**Report: TAB REPORT
Function: Test, Adjust, & Balance
Date: 05/31/2023**

**PROJECT
05-29-23 CULVERS - GRAIN VALLEY, MO**

Diffuser
05/23/2023

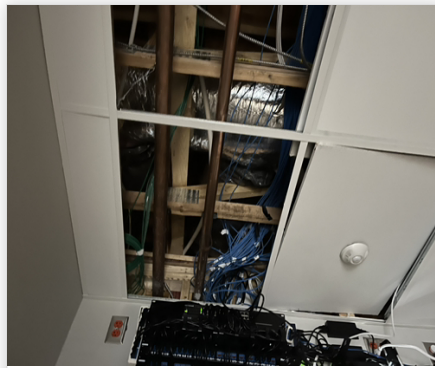
Issue Name : RTU2 diffuser 2-16 very low on flow, takeoff not accessible
Description : Diffuser 2-16 on the GRD for the electrical room is very low on flow at 124 of 600 CFM. This value hasn't changed with moving air around which implies the damper is closed at takeoff, however tech is unable to reach takeoff to check for a damper due to ceiling restrictions.
Created By : National TAB **Assigned To :** National TAB - Jacob Davidson
Status : Open
Originated Date : 05/23/2023 - Jacob Davidson - National TAB

Loosezip
05/23/2023

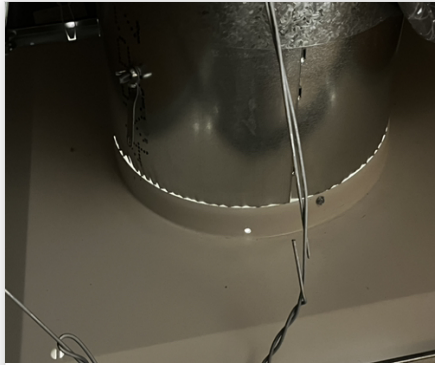
Issue Name : RTU2 low flow, solid duct not sealed
Description : RTU2 is low on flow at 5573 of 6225. The solid duct around many of the diffusers is not sealed and air is escaping above ceiling as a result. Some of the takeoffs and solid duct zip ties are loose as well. These ducts need to be sealed and flex needs to be checked to make sure it stays attached.
Created By : National TAB **Assigned To :** National TAB - Jacob Davidson
Status : Open
Originated Date : 05/23/2023 - Jacob Davidson - National TAB
